Design Exception #7

Height Exception for Sculpted Shotcrete Walls at MP185 and MP187

I-70 West Vail Pass Safety and
Operations Improvements

Wall at MP187

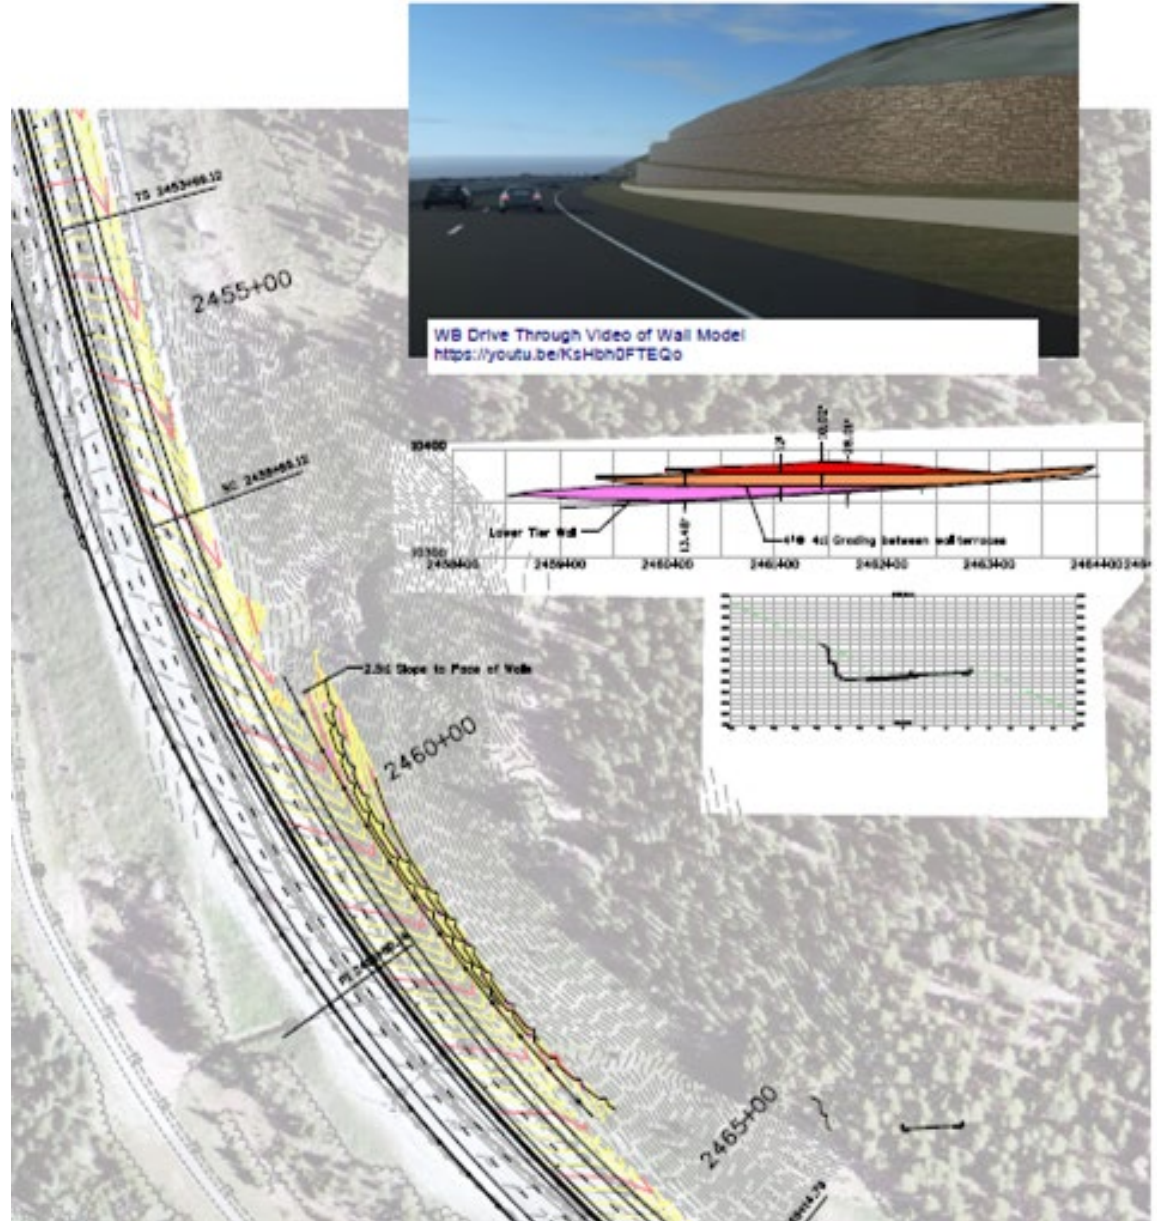
How will drainage be handled?

What is the actual height of the walls?

What is the length of walls over 12'?

Confusing statement “rock sculpting was considered on the existing rock.”

Walls at MP 187 were refined to minimize the total area and height of the walls. Using the existing rock was considered at MP 187. The existing rock is not stable enough to ensure a long-term face without rock falls. This wall has a 13.5' maximum height and is 550' long, with approximately 9% of the wall over 12' in height.

The wall is following the falling topography from east to west. Water will be directed along the top and bottom of the wall and channeled into drainage features. If the natural drainage currently flows directly toward the road, the wall may be sculpted to allow water to fall over and down the face.
